# ***Errata to*** **2012 Edition** **National Electrical Safety Code®**

*Correction Sheet*  
**Issued 29 April 2013**

**Figure 234-4(b)—Clearance envelope for grain bins filled by portable augers, conveyors, or elevators**

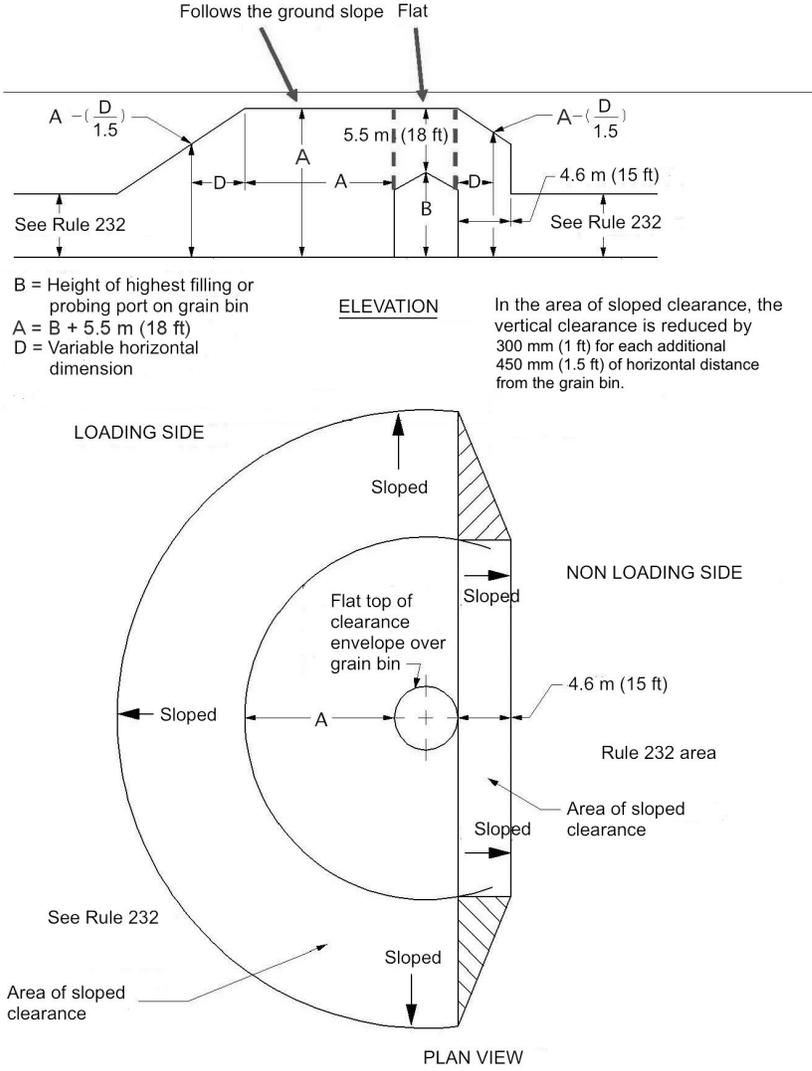
**Page129:** There are three errors in Figure 234-4(b). At the top of the figure, the two instances of “H” should read “A.” The text associated with “A” in the legend should read “B + 5.5 m (18 ft)” and not “V + 5.5 m (18 ft).”
